A-7010 GSL
A-7030 GSL

STEREO TAPE DECK

SERVICE MANUAL

TEAC® MANUAL CHANGE SHEET

ABOVE THE MAIN CHASSIS

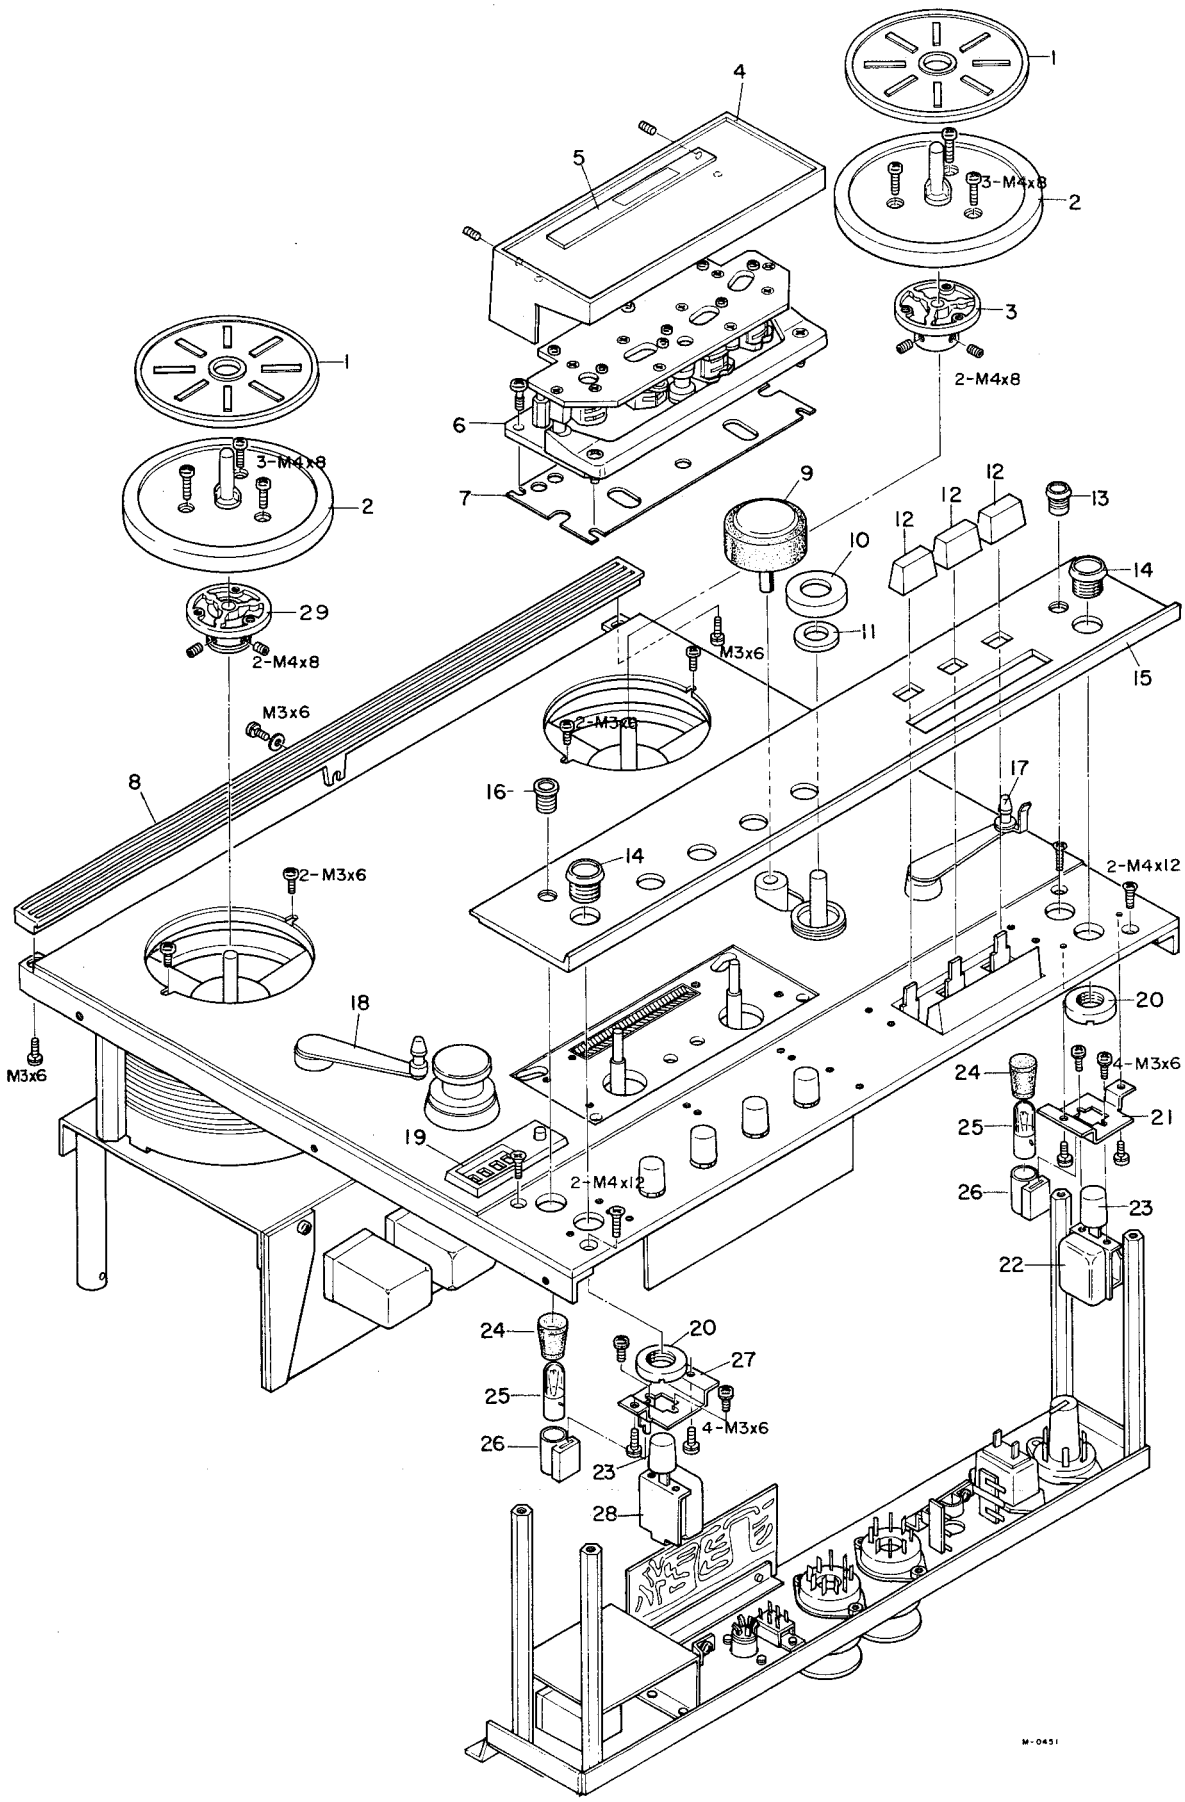
NOTE:
* Asterisk-indicated parts have been replaced by a complete assembly and are only available in the "Quik-Lok" Reel Table Assembly. For any of these parts, order TEAC Part Number 50160421 Reel Table Assy.

This change is applicable from Unit Serial Number 28741 (A-7010GSL) and 26391 (A-7030GSL).

"Quik-Lok" Reel Holder reel tables are standard with later models of this deck and are completely interchangeable with the earlier type illustrated.

P.S. AMPL. CIRCUIT CHANGE

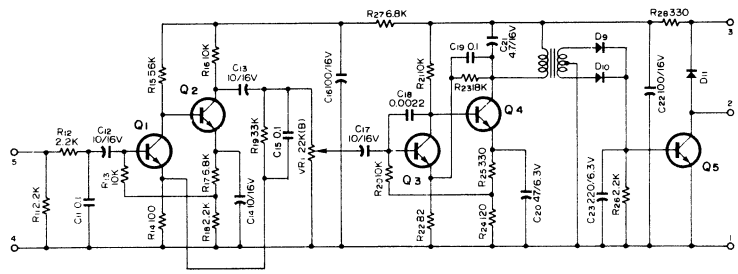
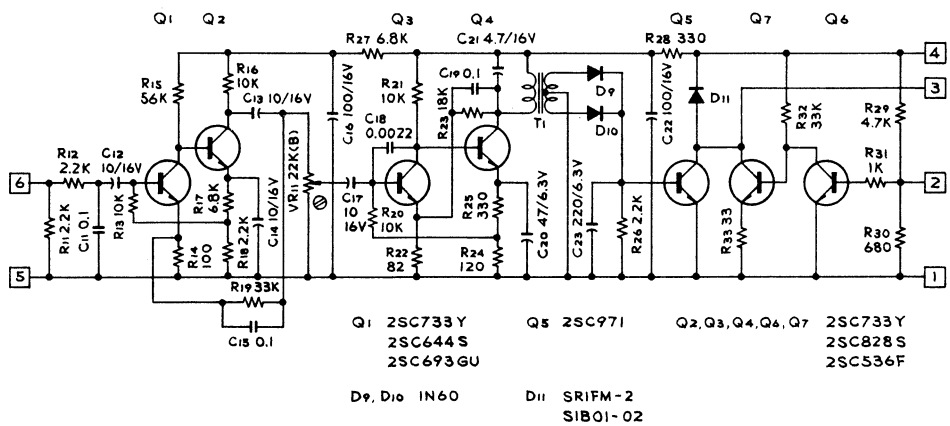
The sensing post of the automatic reverse circuit has been the source of noise when using back-coated tapes, such as SONY SLH-BL, Scotch #206 or 207, and others. A new printed circuit board assembly is now being used to eliminate this problem. (See diagram.) If the customer desires, his older model may be modified to include this change. Order part #50491040

COUNTER IDLER PULLEY CHANGE

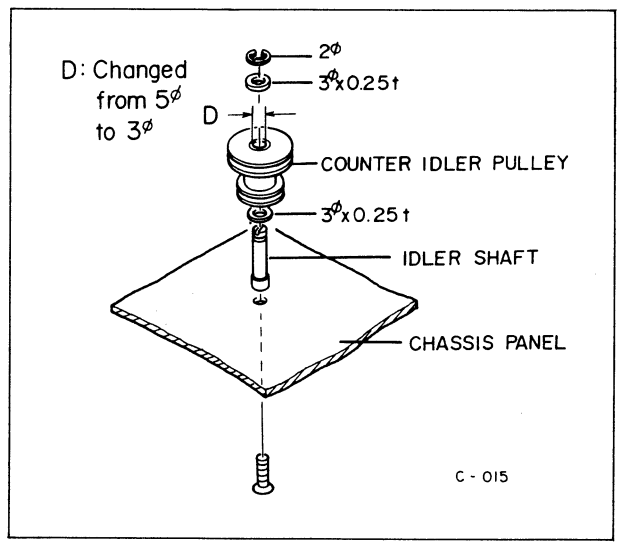
When replacing either the Idler Pulley Shaft or the Counter Idler Pulley, they must both be replaced at the same time, due to the incompatibility between the old and new diameters. This applies especially to the older models (before this change was incorporated) and it is also a good practice to replace both parts during any replacement to provide uniform wear characteristics between the parts.
